**Economic and Social Council**Distr.: General
3 March 2023

World Forum for Harmonization of Vehicle Regulations**Working Party on Passive Safety****Seventy-third session**

UN Regulation No. 94 (Frontal impact)**Proposal for the 05 series of amendments to UN Regulation No. 94 (Frontal collision) *****Submitted by the expert from the International Organization of Motor Vehicle Manufacturers**

Arrangements of Approval Marks

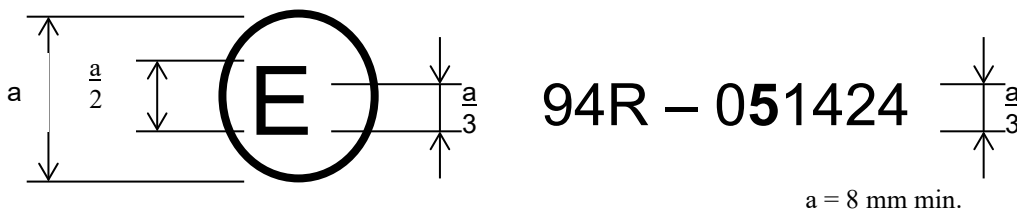
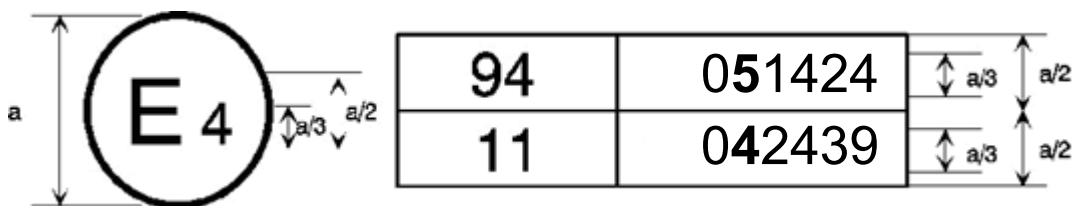
Annex 2, amend to read:

The above approval mark affixed to a vehicle shows that the vehicle type concerned has, with regard to the protection of the occupants in the event of a frontal collision, been approved in the Netherlands (E 4) pursuant to UN Regulation No. 94 under approval number 051424. The approval number indicates that the approval was granted in accordance with the requirements of UN Regulation No. 94 as amended by the 04 series of amendments.

The first two digits of the approval numbers indicate that, at the dates when the respective approvals were granted, UN Regulation No. 94 incorporated the 05 series of amendments and UN Regulation No. 11 incorporated the 04 series of amendments."
